June 23, 2021
E-58840

Subject: Application for Amendment 3 to NUHOMS® EOS Certificate of Compliance No. 1042, Revision 1 (Docket 72-1042, CAC No. 001028, EPID: L-2021-LLA-0055) – Response to Request for Supplemental Information

This submittal provides responses to the Request for Supplemental Information (RSI) forwarded by Reference [1] above. Enclosure 2 herein provides a proprietary version of the response to the RSI and Observation (OBS) items. Enclosure 3 provides a public version of these responses. Each RSI and OBS response has a section stating the impact of the response on the application, both Technical Specifications (TS) and updated final safety analysis report (UFSAR), indicating which sections, tables, etc., have been changed.

Figure 4F
Heat Load Zone Configuration 6 for the 61BTH Type 2 DSC

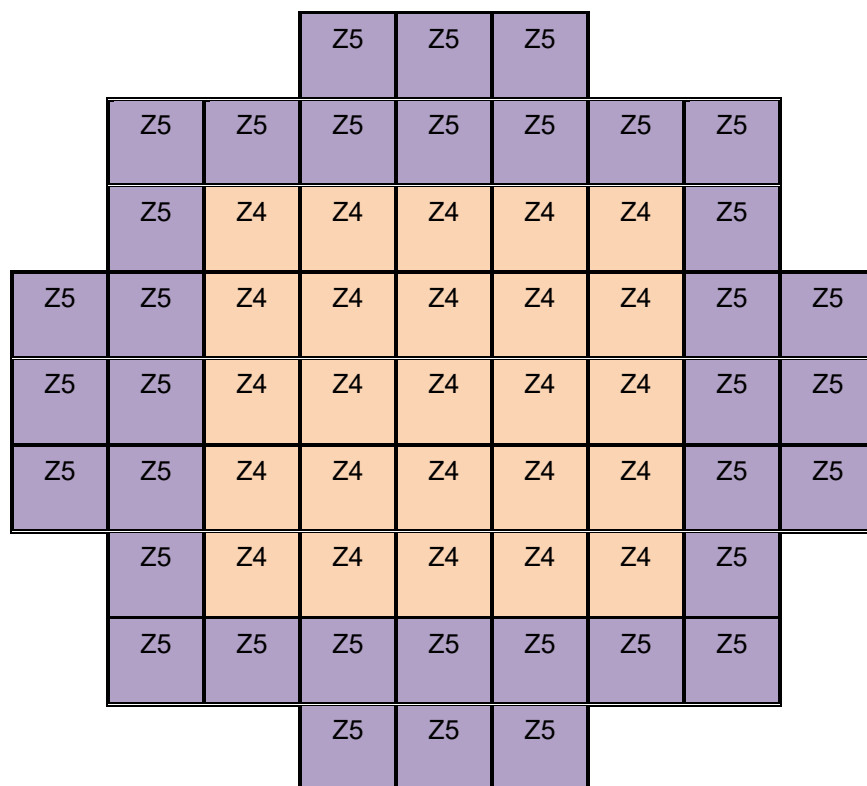
The NUHOMS® EOS System TS Figure 4F note 1 states, "Adjust the payload to maintain total DSC heat load within the specified limit," which is 31.2 kW and found in the table that is located below Figure 4F. However, when adding the maximum decay heat per zone for each of the six zones, the total is 31.18 kW, which is already less than 31.2 kW specified in the table. Therefore, for the NUHOMS® EOS System TS Figure 4F, if the per assembly decay heat values are correct, the payload to maintain the total DSC heat load does not need to be adjusted, and then note 1 does not appear to be necessary. In this case, the payload should not be adjusted to exceed 31.18 kW while also remaining below 31.2 kW.

Figure 4F of the Technical Specification (TS) has been updated to remove Note 1 since the sum of the total heat per zone among the various zones results in a heat load that is less than 31.2 kW.

TS Figure 4F has been revised as described in the response.

Figure 10
Empty Locations in Short-Loading Configurations for the EOS-89BTH DSC

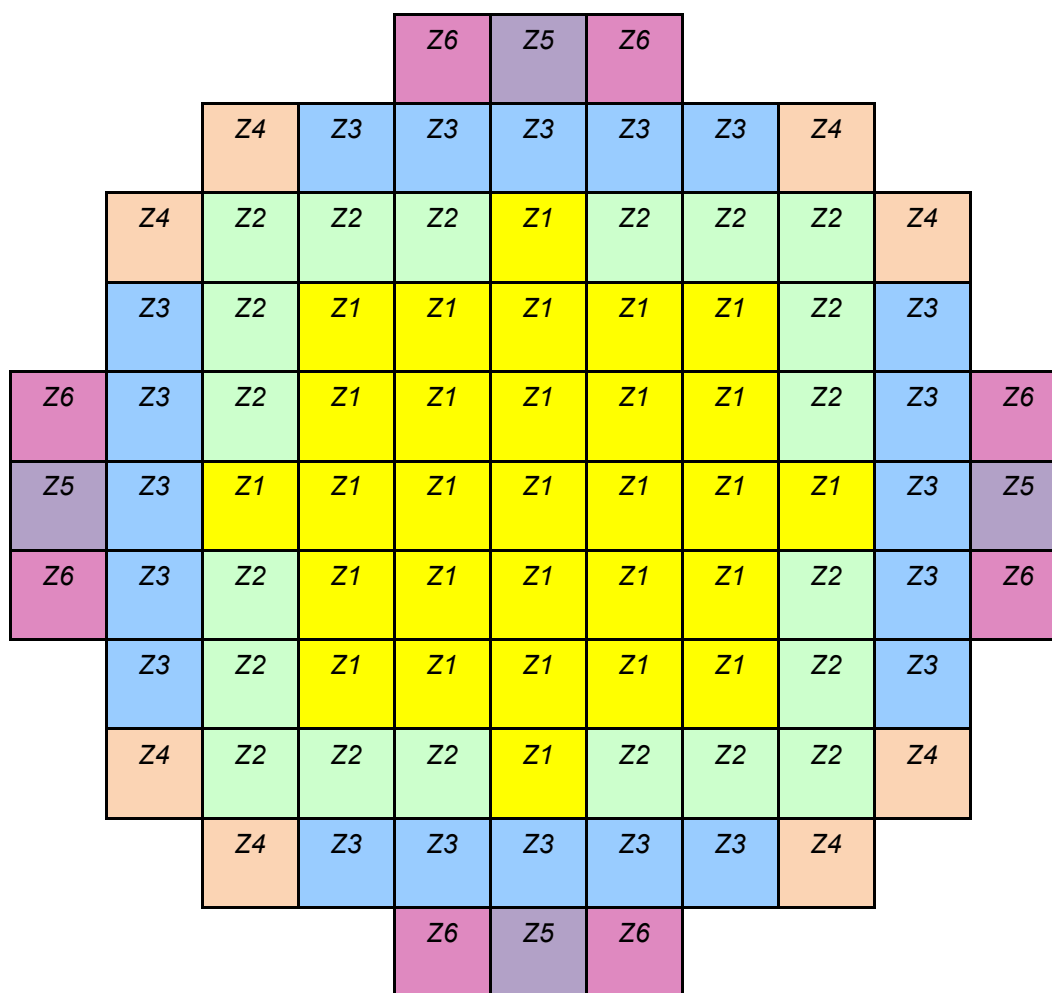
Revise the application to provide the locations of short and long partial-length rods in the ATRIUM 11 fuel assembly, and to discuss how this fuel was modeled in the criticality analysis.

The applicant requested that the ATRIUM 11 fuel assembly be added as an allowable fuel type for storage in the EOS 89BTH canister. Table 2-3 of the UFSAR provides the assembly design characteristics for the ATRIUM 11 fuel assembly design, including the numbers and lengths of the full length, short partial-length, and long partial-length rods. However, the UFSAR does not show the location of the short and long partial-length rods in the assembly lattice. The UFSAR should be revised to include this information. Additionally, the criticality chapter of the UFSAR does not describe how the ATRIUM 11 assembly was modeled. The UFSAR should be updated to describe whether the partial-length rods were modeled actual length, full length, or missing, and if the central water rod channel is modeled as designed or replaced by water, and demonstrate that the assembly configuration modeled is conservative.

Figure 7-31 is added to Updated Final Safety Analysis Report (UFSAR) Chapter 7 to illustrate the numbers and lengths of the full length, short partial-length, and long partial-length rods. Figure 7-27 is modified to add views of the 100 and 92 rod lattices. In addition, a sensitivity analysis is performed and documented in UFSAR Section 7.4.3 C to provide the basis for the bounding lattice model employed for determining the maximum enrichments for ATRIUM 11 fuel type loaded in the EOS 89BTH Dry Shielded Canister (DSC). The sensitivity analysis encompasses the ATRIUM 11 fuel design characteristics including non-uniform, and uniform pitch, and numbers and lengths of the full length, short partial-length, and long partial-length rods (new UFSAR Figure 7-31). The results of the sensitivity analysis, new UFSAR Table 7-82, show the bounding ATRIUM 11 lattice is that with uniform pitch of 1.195 cm and 92 rods. UFSAR Table 7-43 has been revised to report the maximum enrichments for ATRIUM 11 fuel type. UFSAR Figure 7-28 has been revised to update the ATRIUM 11 illustration in the short loading configuration with 88 fuel assemblies.

Technical Specifications (TS) Table 8 has been updated to report the maximum lattice average initial enrichments and minimum B-10 areal densities. TS Table 8A has been deleted and the updated ATRIUM 11 results have been added to TS Table 8. TS Figure 10 has been updated to modify the empty compartments in the short loading configuration with 84 fuel assemblies.

Figure 10 (Page F-29)	As described in the response to Shielding RSI 6-1, Figure 10 has been revised.
